NAC INTERNATIONAL

Subject: Docket No. 71-9270 (TAC No. L22452)

Submittal of the NAC Responses to the NRC Request for Additional Information (RAI) on the UMS® Universal Transport Cask Application, Chapter 2 Structural Evaluation

Figure 2.51-1 Upper Impact Limiter Acceleration - 30-ft End Drop

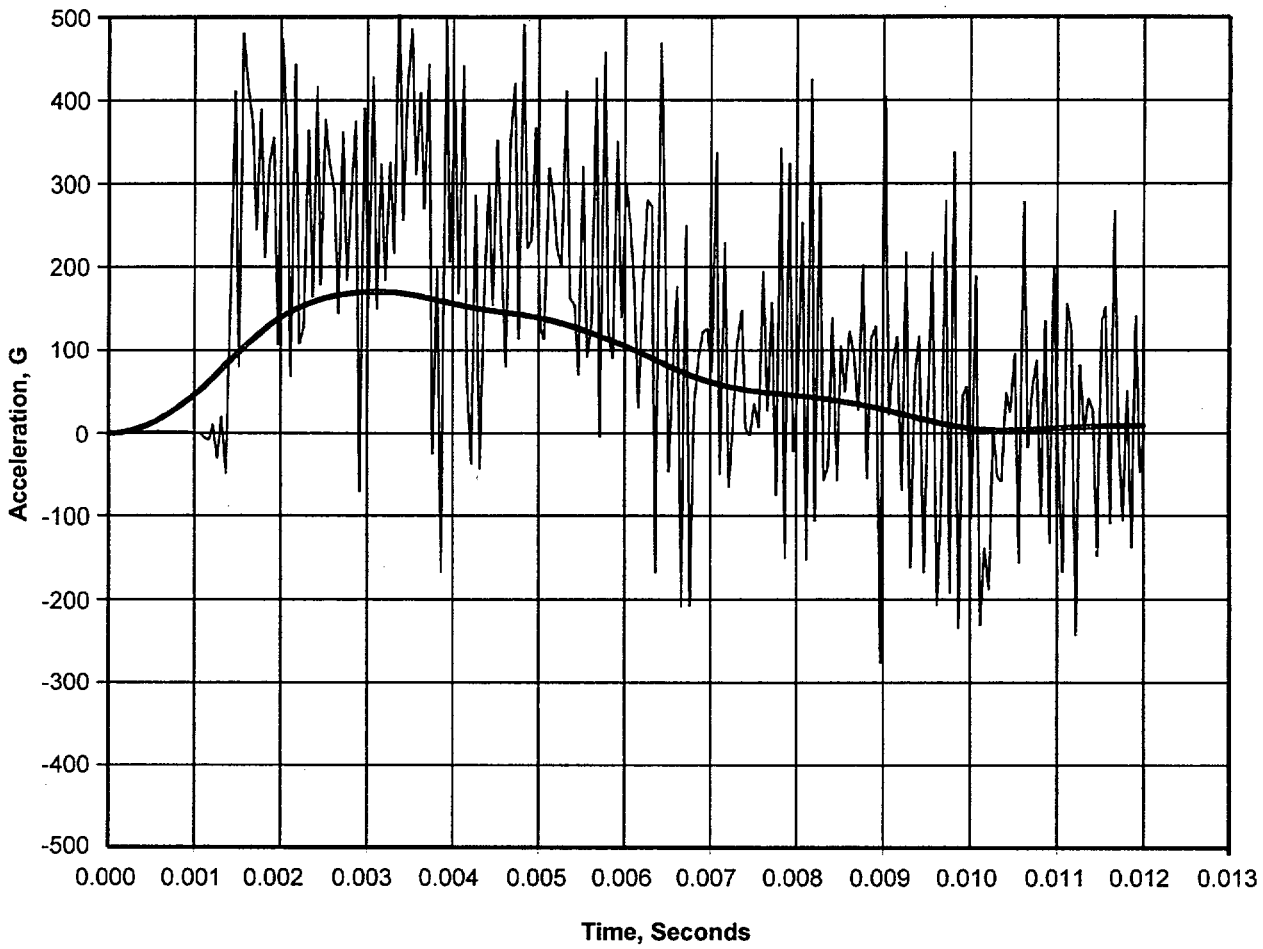
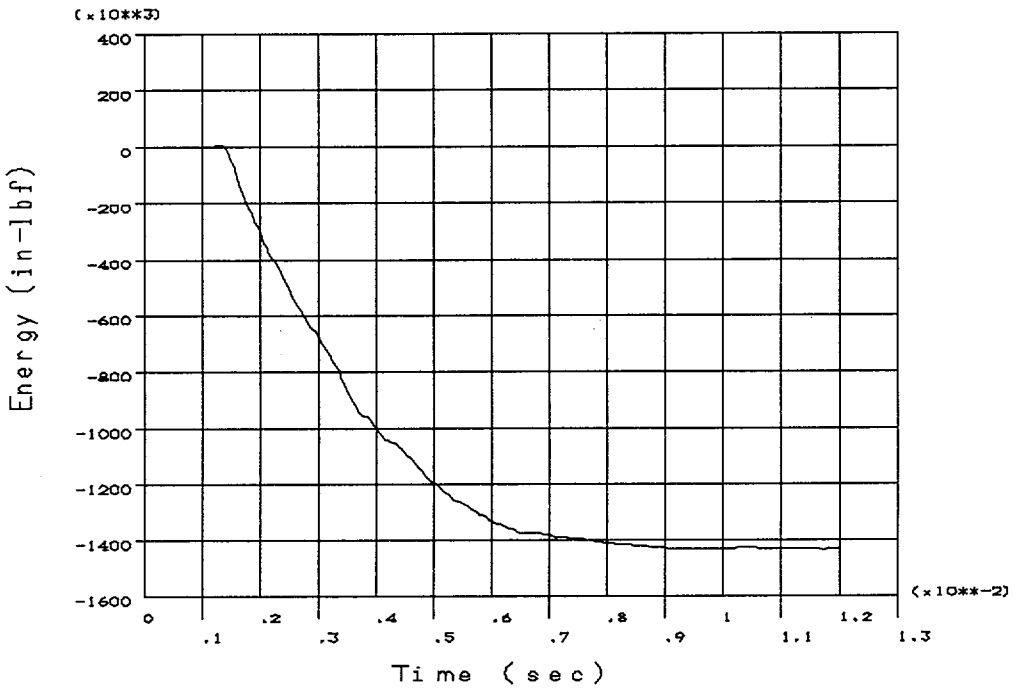
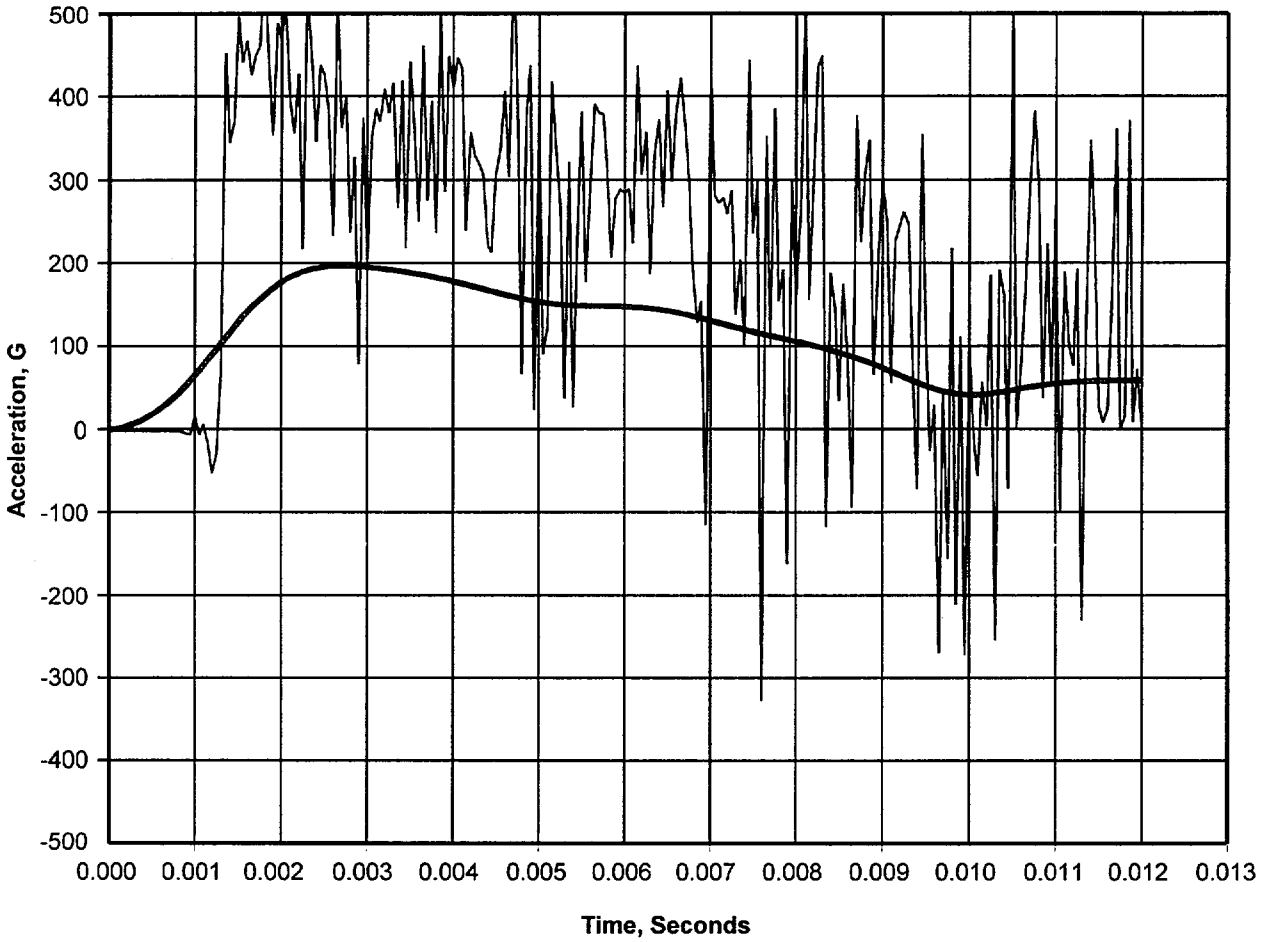
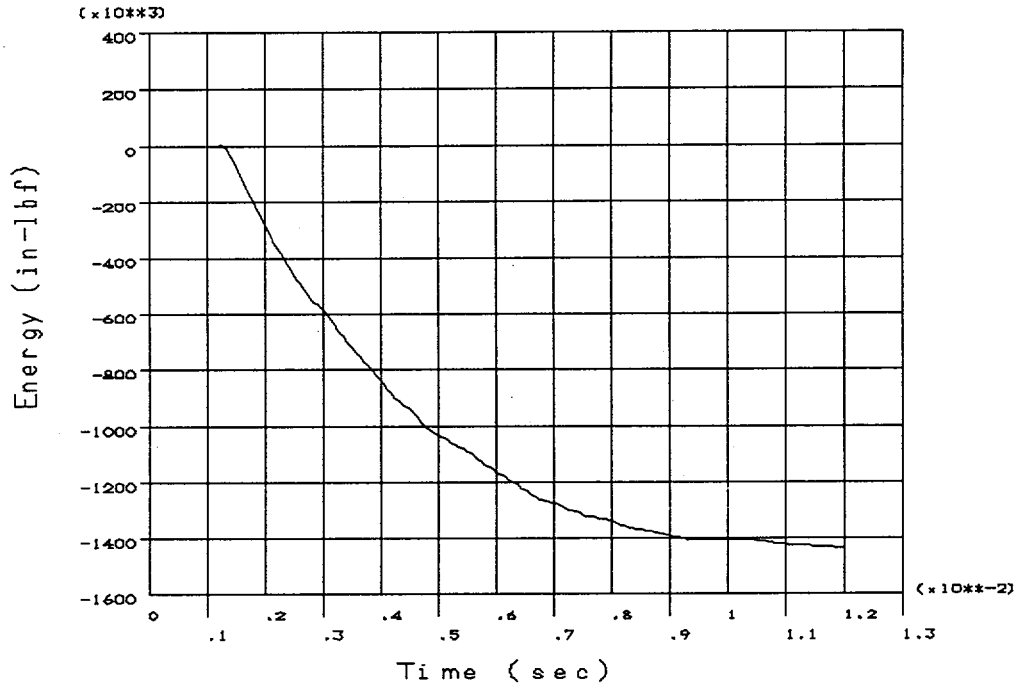
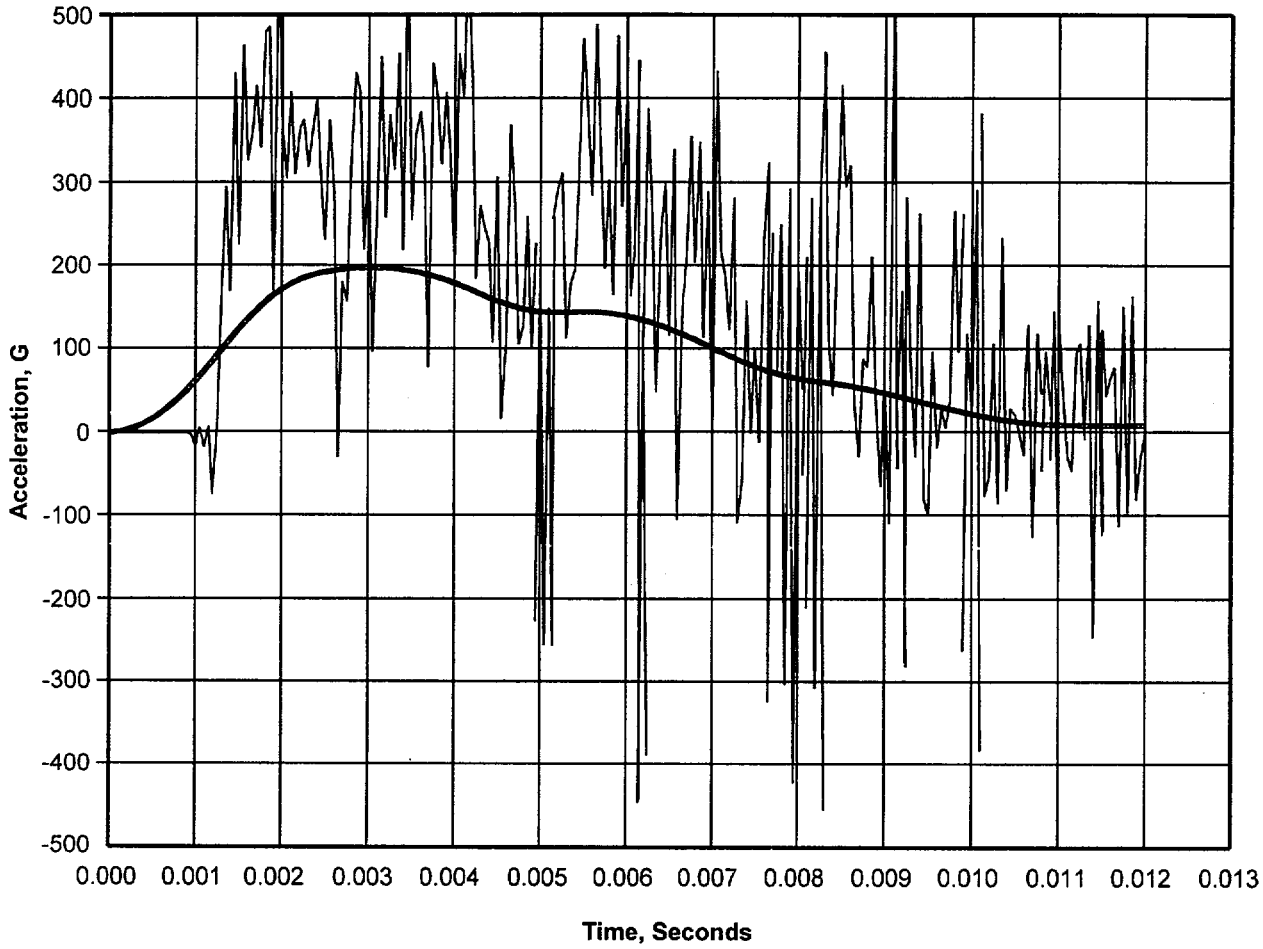
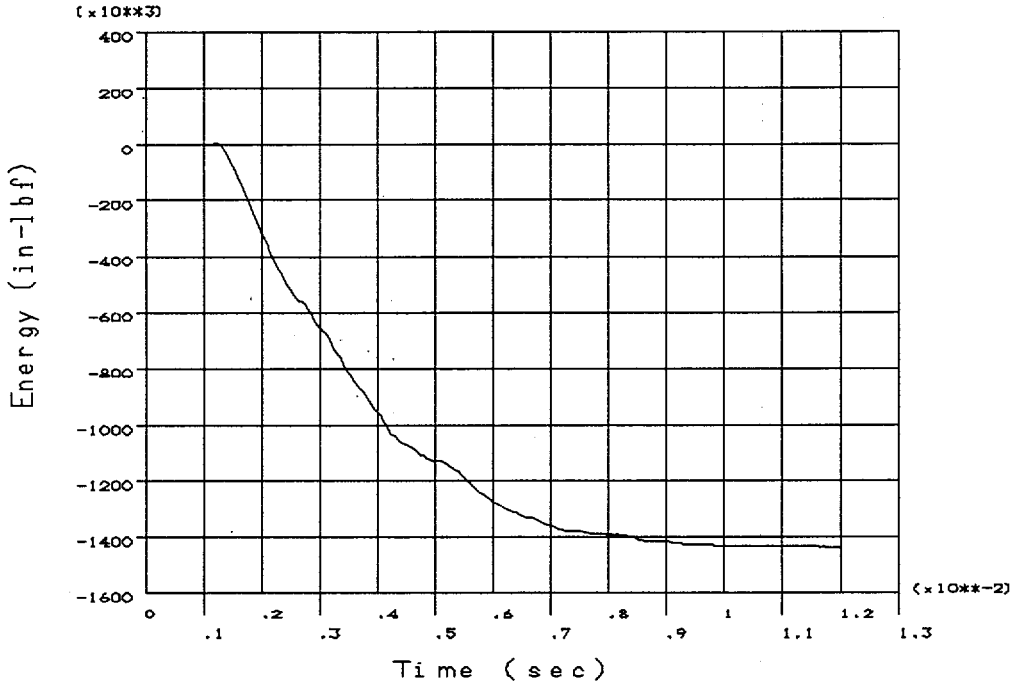
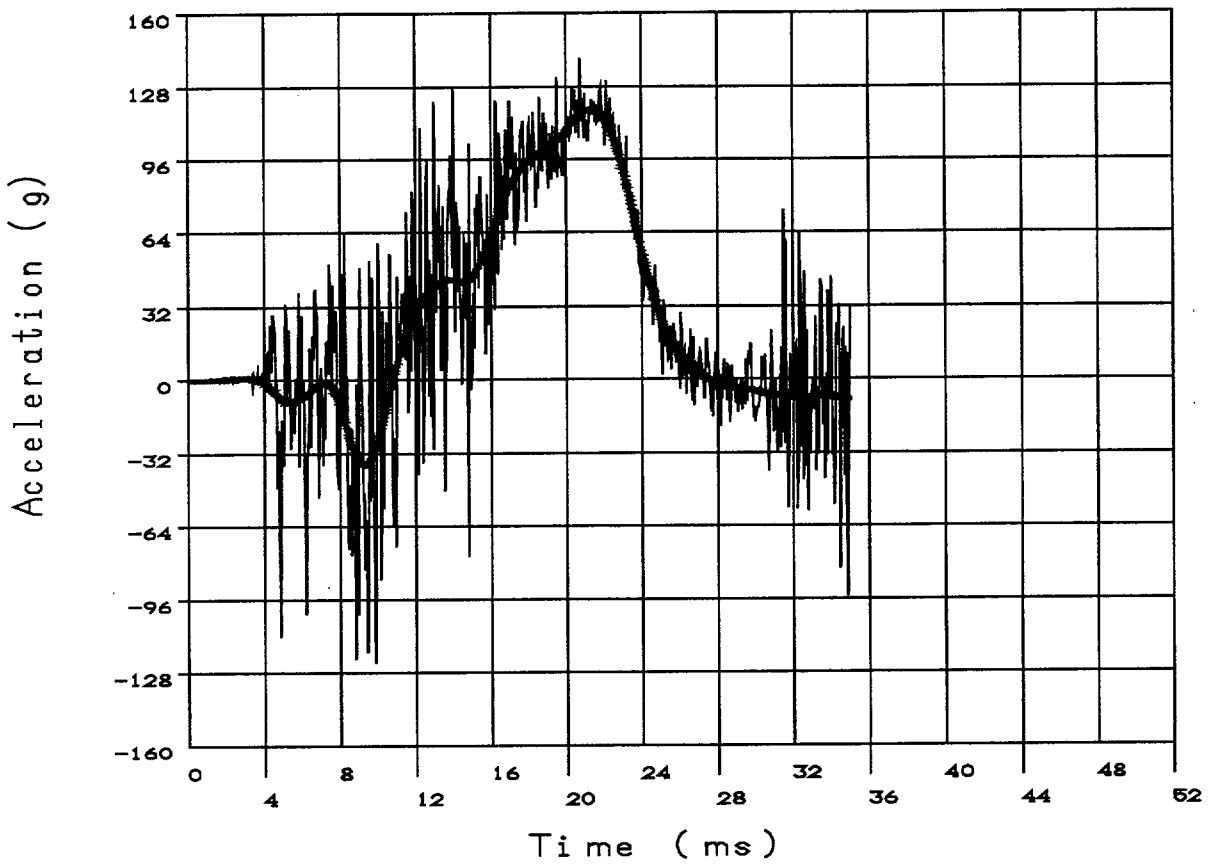
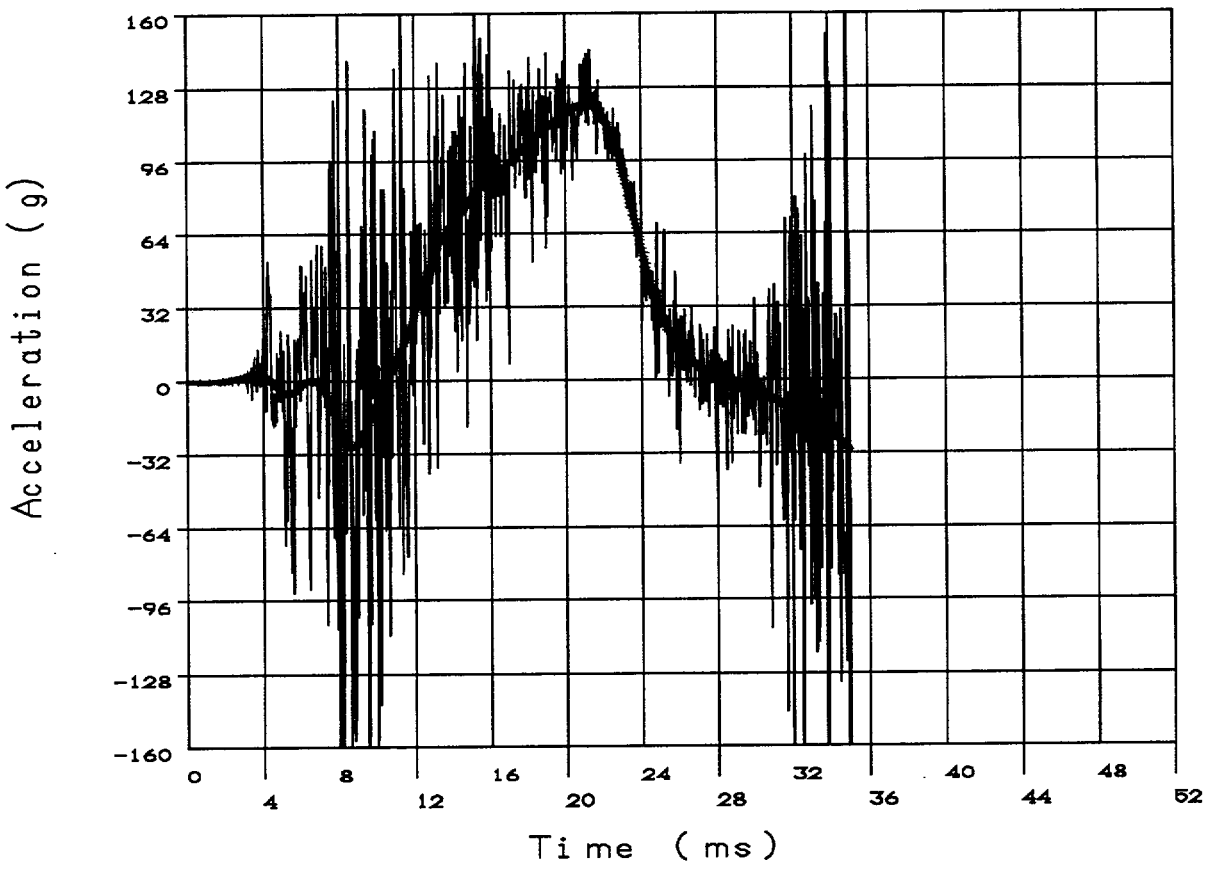
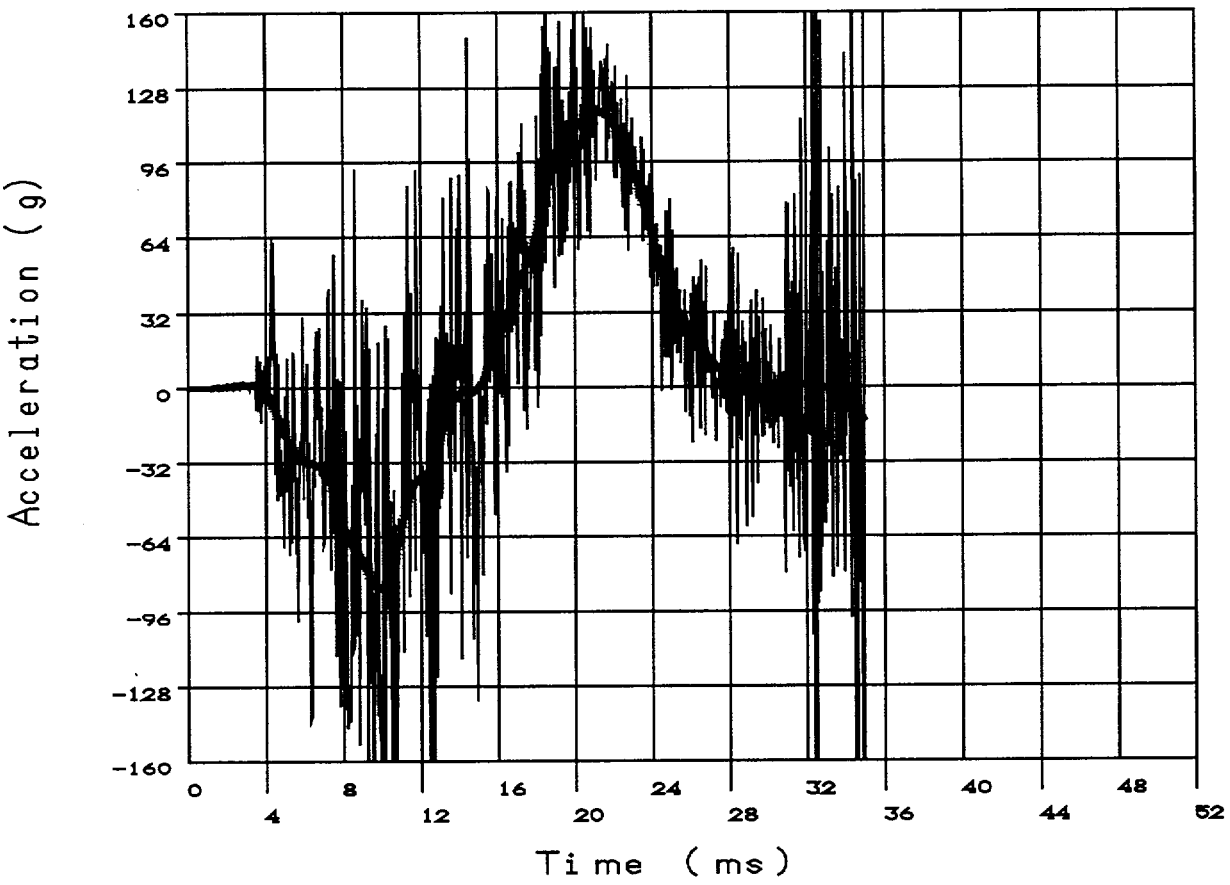
3. The end-drop acceleration time history in Figure 2.10.3-1 appears to contain much more spurious components than the similar time history for the 1/4-scale drop test conducted for the NAC-STC.

The filtered and unfiltered acceleration time history traces and energy data curves for the top 30-foot end drop are provided in Figures 2.51-1 through 2.51-6 of this response. Acceleration data from the three accelerometers used in the 30-foot top end drop test are presented in those figures. The filtered data is superimposed on the unfiltered data. The 30-foot top corner drop unfiltered and filtered acceleration data are provided in Figures 2.51-7 through 2.51-9.
